802.3dj D1.3 Comment Resolution Optical Track

Tom Issenhuth (Huawei)
Matt Brown (Alphawave Semi), 802.3dj Chief Editor

Comment #333

Figure 121-4—TDECQ conformance test block diagram

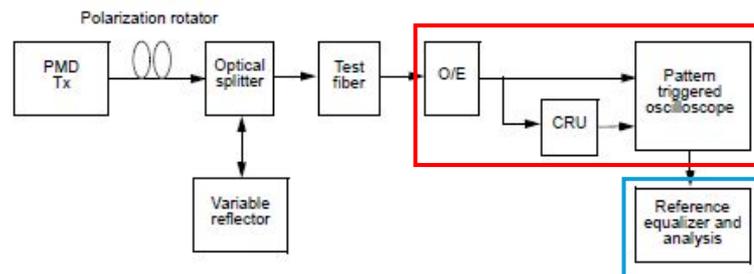
- While the wording is a bit awkward, it's clear that the **reference receiver** is distinct from the **reference equalizer**, and does not contain it.
- This is reinforced in 121.8.5.1, Figure 121-4, which shows the **reference equalizer** separate from the O/E and calibrated oscilloscope that form the **reference receiver**.
- It's unfortunate that the text in 121.8.5.1 doesn't repeat the term, **reference receiver**, which is a source of some of the current confusion.
- Another source of confusion comes from the fact that the **reference equalizer** is typically implemented in the oscilloscope but is not defined as part of the **reference receiver**.
